# dsPIC33CH512MP508

## dsPIC33CH512MP508 Family Silicon Errata and Data Sheet Clarification

The dsPIC33CH512MP508 family devices that you have received conform functionally to the current Device Data Sheet (DS70005371D), except for the anomalies described in this document.

FIGURE 1-1: I/O RAMP

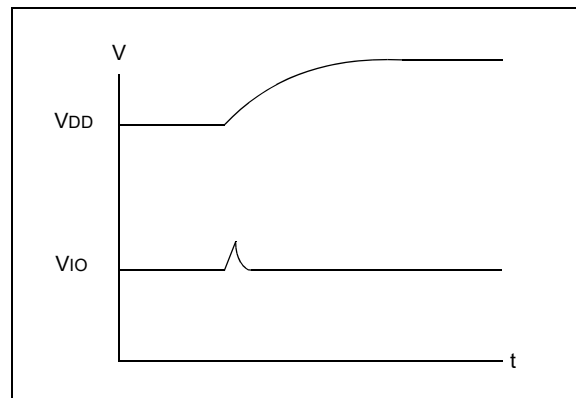
During a fast device power-up, when the VDD ramp is less than 4 mS, the I/O pins may drive up to 100  $\mu$ A current for a duration of up to 10  $\mu$ S (Figure 1-1).

1. Slow down the VDD ramp time (greater than 4 mS for VDD to ramp 0V to 3.3V).
2. Ensure the circuitry that is connected to the pins can endure this pulse.

Example applications affected may include complementary power switches, where a transient current shoot-through might occur. High-voltage applications with complementary switches should power the high-voltage 200  $\mu$ Sec later than powering the dsPIC<sup>®</sup> device to avoid the current shoot-through. This behavior is specific to each device and not affected by aging.
